Addendum #01

Project Name: Proposed Renovation and Addition: Ellisville City Hall and Police Station

Project Number: 20016

Date: 2023-03-17

A302

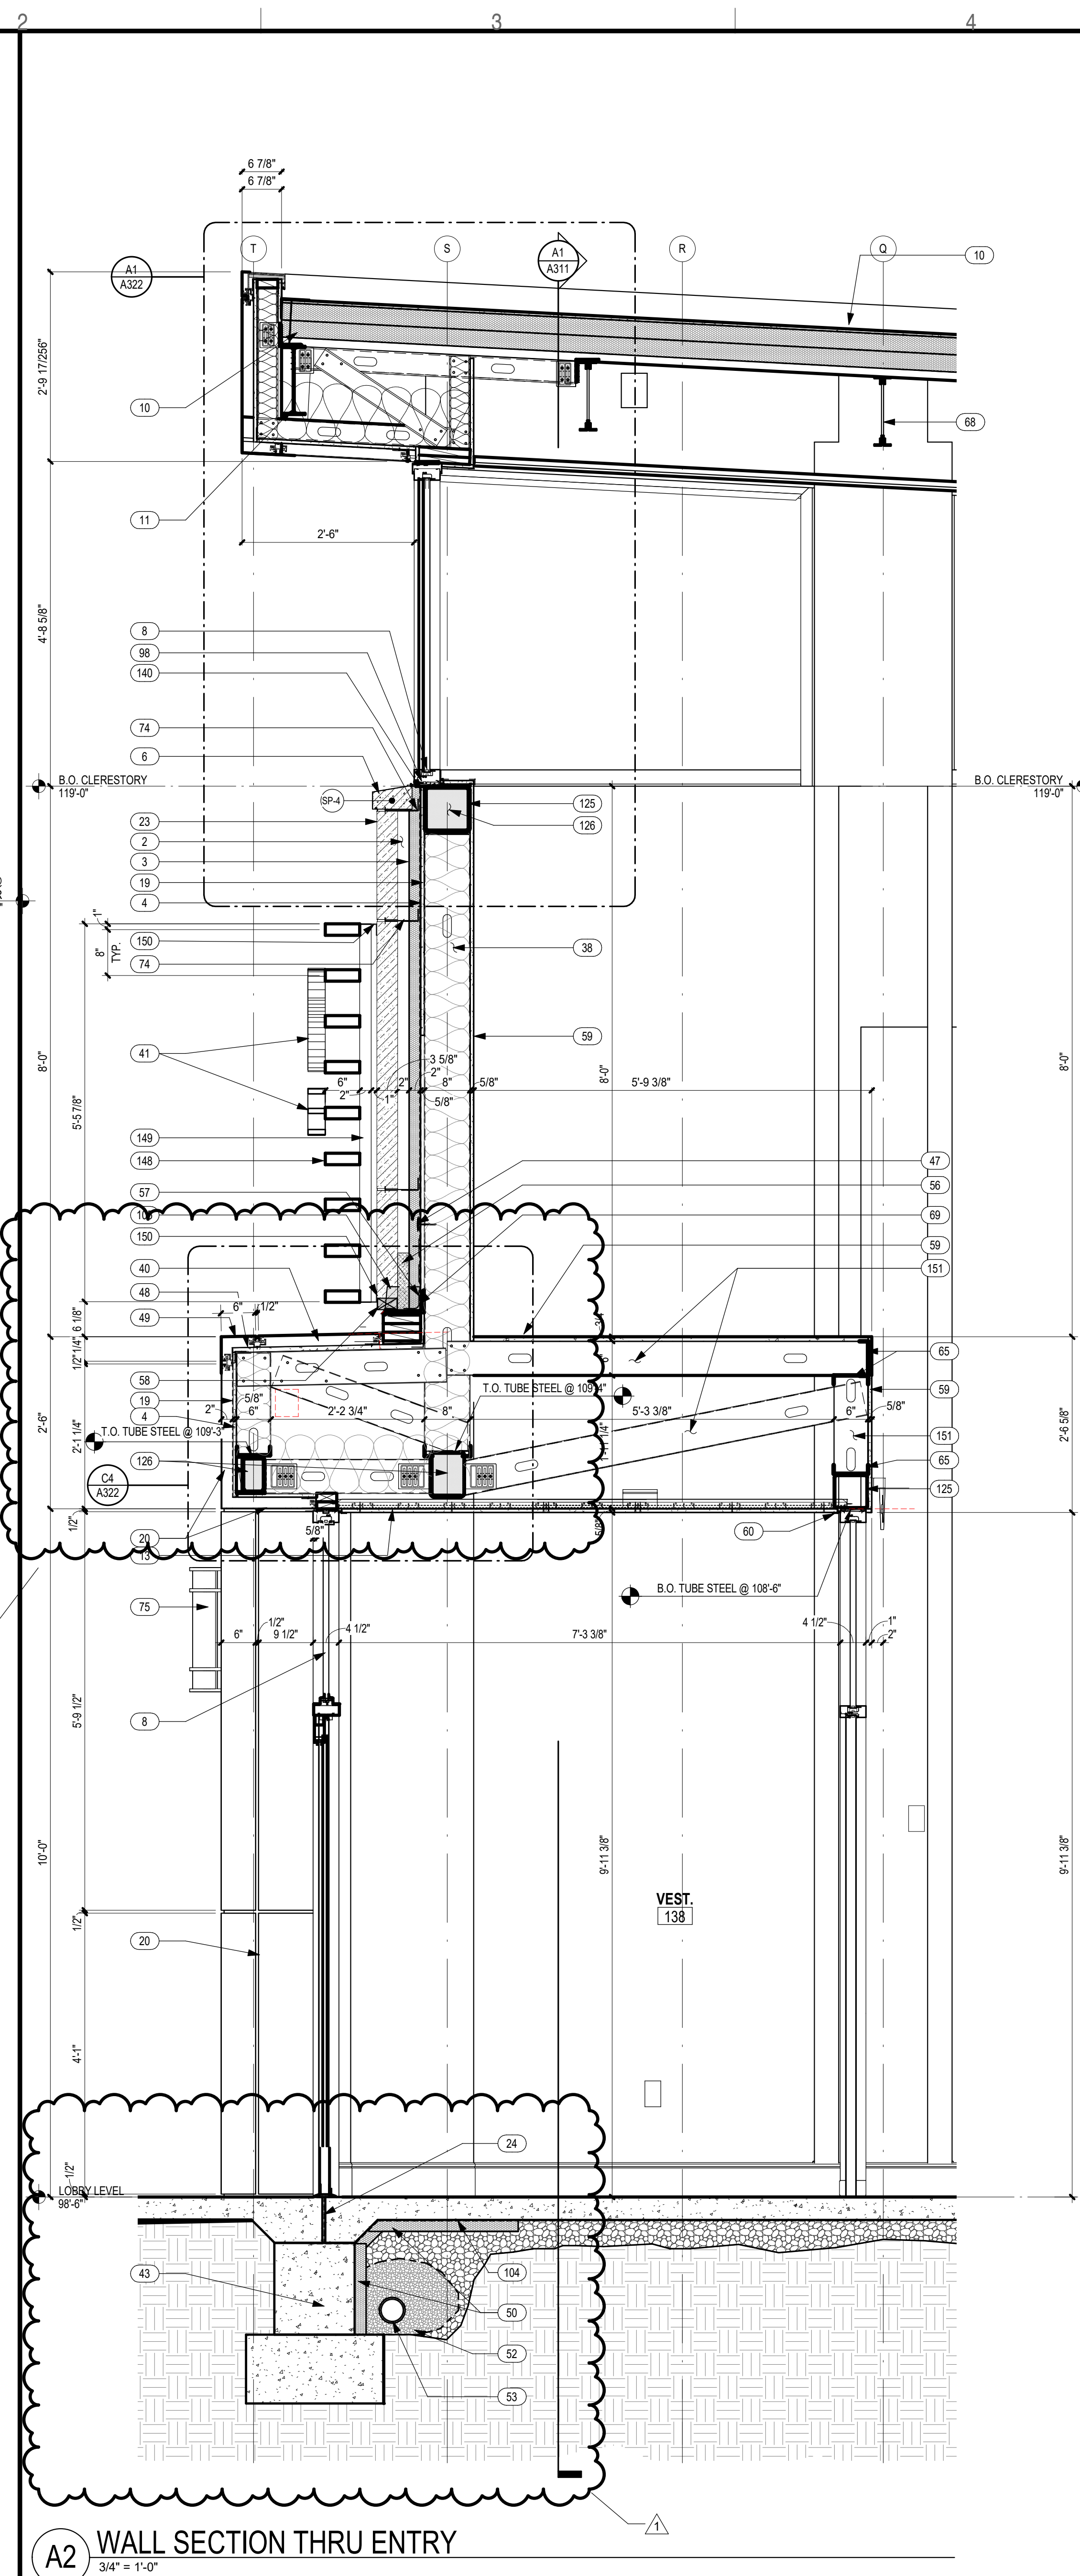
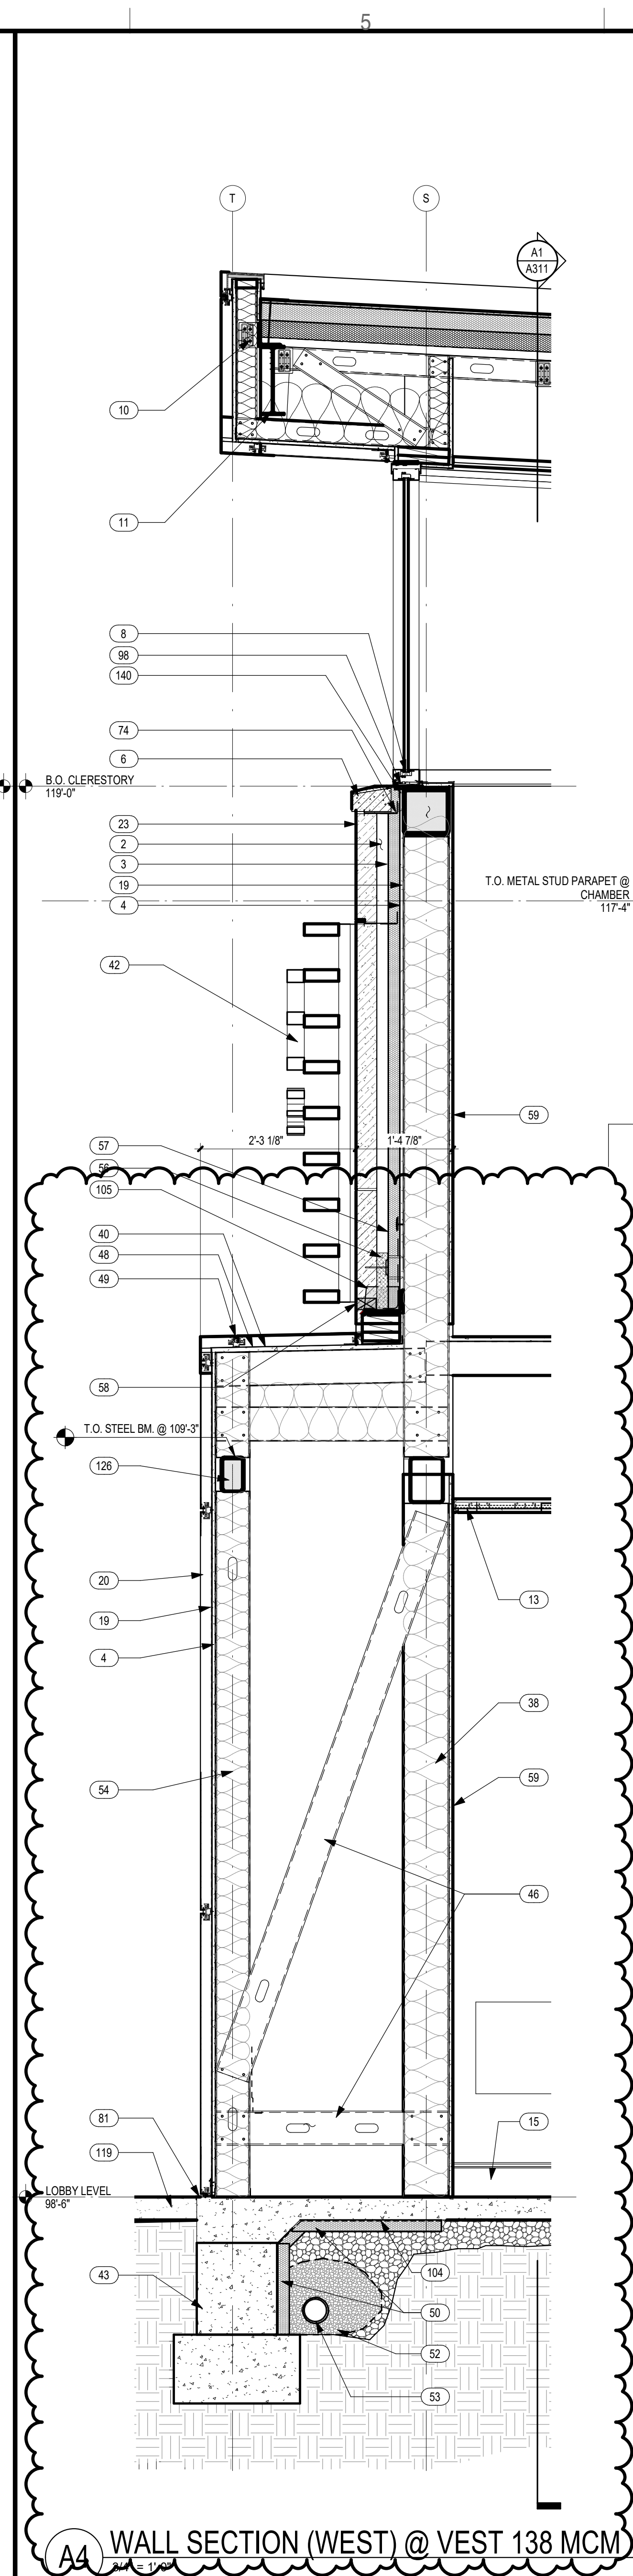
- b. **Reference attached Revised Sheet.**
5. Sheet A302: Wall Sections
 - a. **A2, revised Keynotes at foundation.**
 - b. **A4, added Keynotes at Wall Section.**

13 TYPICAL DECK ANGLE SPLICE DETAIL
S106 NTS

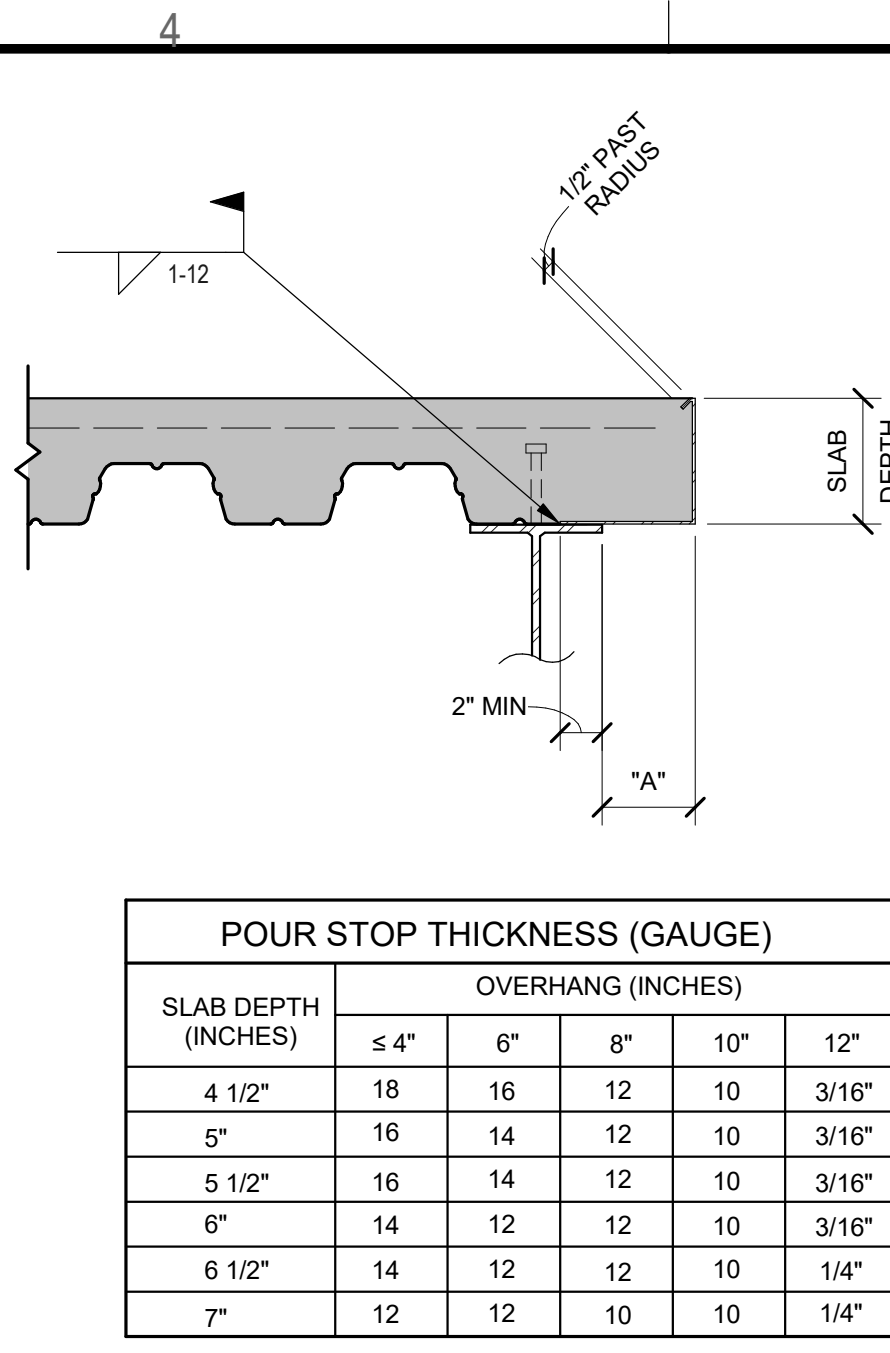
1. Sheet S101: General Notes
 - a. **Revise Paragraphs 1.3.I, 1.4, 1.5A, 1.5C and 1.5D, of the Structural General Notes.**
 - b. **Reference attached Revised Sheet.**
2. Sheet S106: Typical Details
 - a. **Added Typical Details 13, 14 and 16.**
 - b. **Reference attached Revised Sheet.**
3. Sheet S107: Typical Details
 - a. **Revised Detail 3 and added Detail 14.**
 - b. **Reference attached Revised Sheet.**
4. Sheet S108: Loading Diagrams
 - a. **Added uplift pressure symbol on Plan 2.**
 - b. **Reference attached Revised Sheet.**
5. Sheet S201: Foundation Plan-Level 1
 - a. **Revised Foundation and Section Marks on south side between Grids 18 and 13.9.**
 - b. **Revised TP and Section Mark in storm shelter area.**
 - c. **Revised Plan Note #11.**
 - d. **Reference attached Revised Sheet.**

2 COLUMN BASE PLATE
S502 NTS

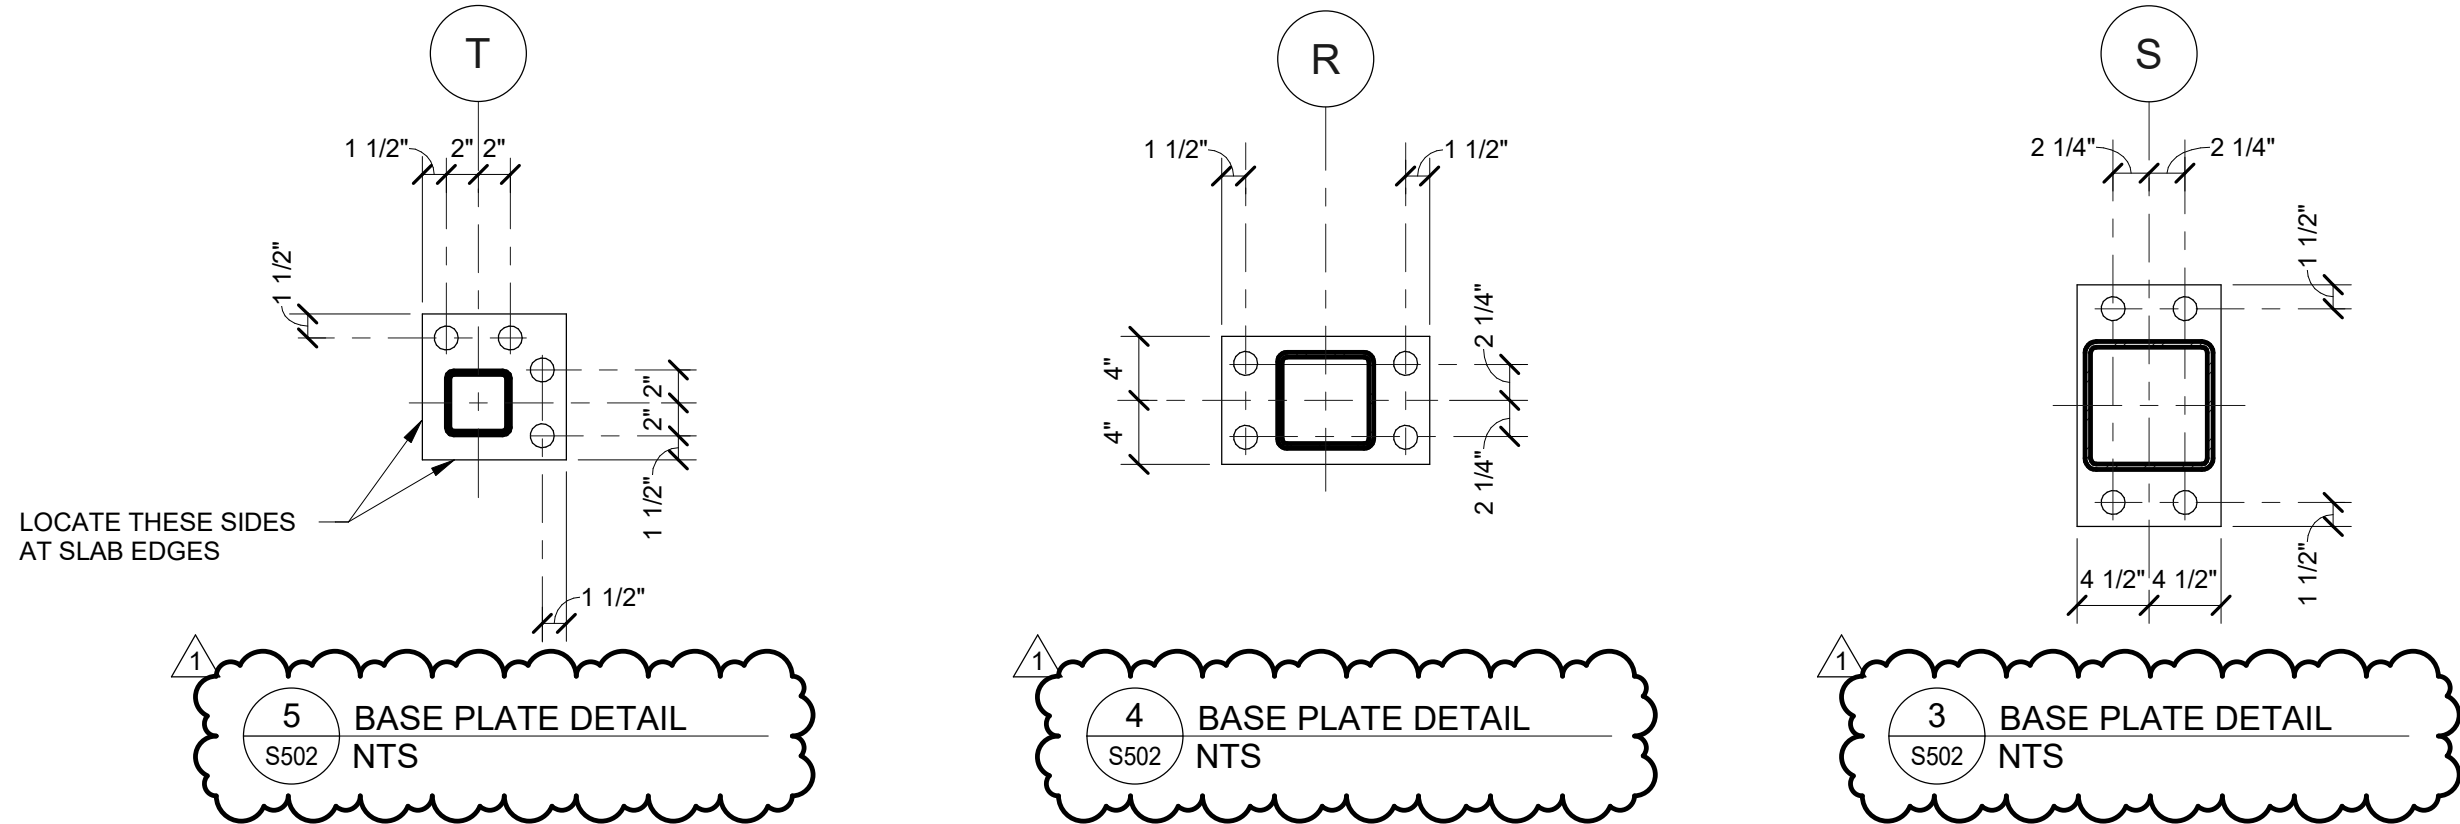
- c. **Reference attached Revised Sheet.**
12. Sheet S502: Column Schedule
 - a. **Revised Column Schedule.**
 - b. **Added Base Plate Details 3 and 4.**

3 RTU 01 SECTION VIEW

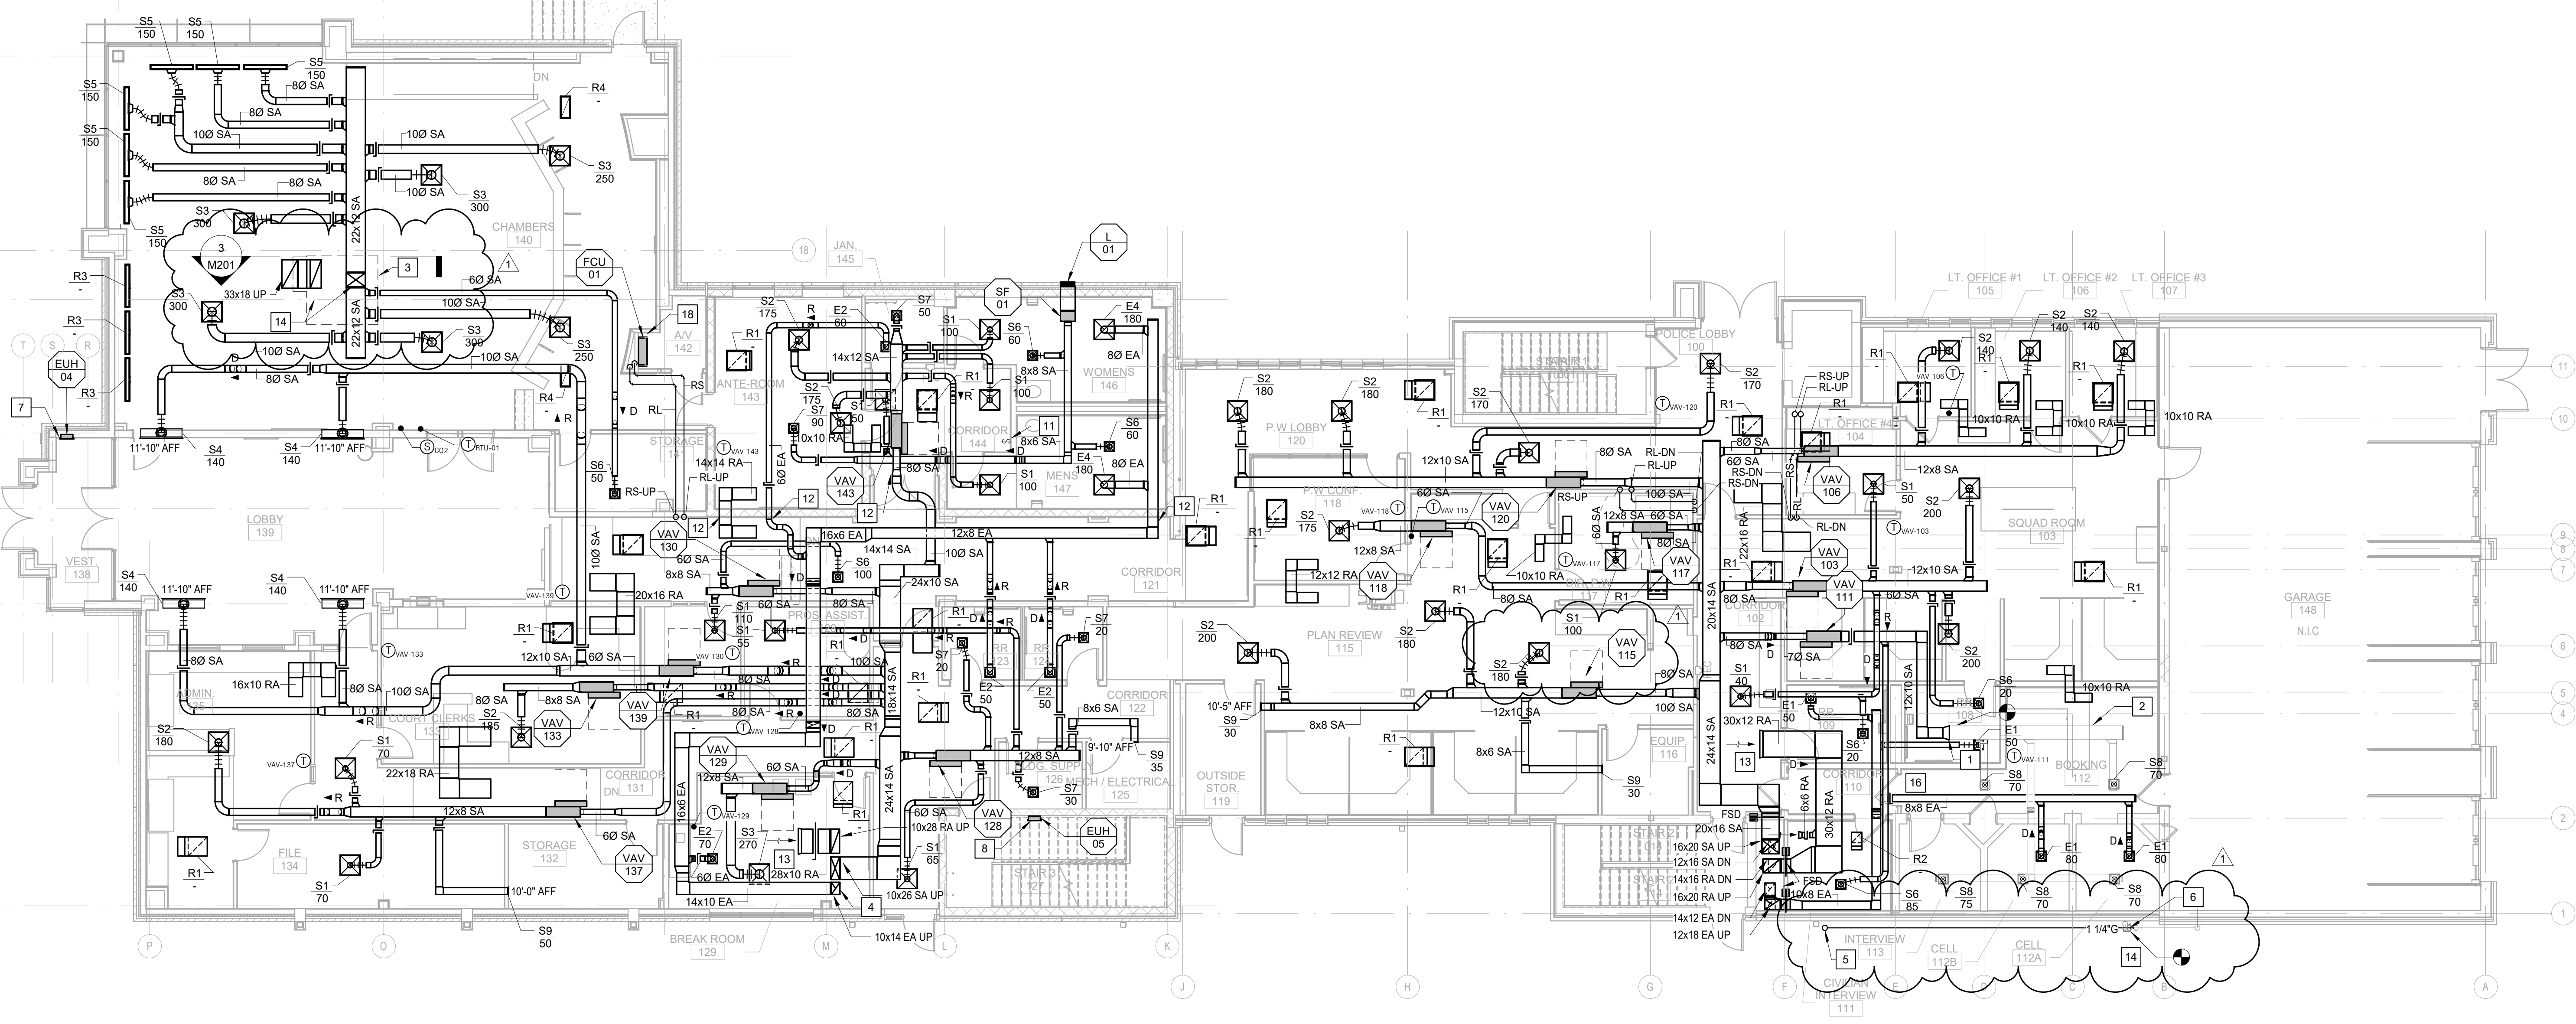
- a. **Updated section view 3 for new RTU 01 selection.**
 - b. **Updated dashed line denoting RTU 01 outline per new selection.**
 - c. **Updated gas line size for increase in MBH from new RTU selections on plan view.**

- d. **Moved VAV 115 tag to uncover supply grill.**
 - e. **Keynote 15 deleted.**
 - f. **Reference attached Revised Sheet.**
3. Sheet M202: Roof and 2nd Floor Plan-Mechanical Base Bid
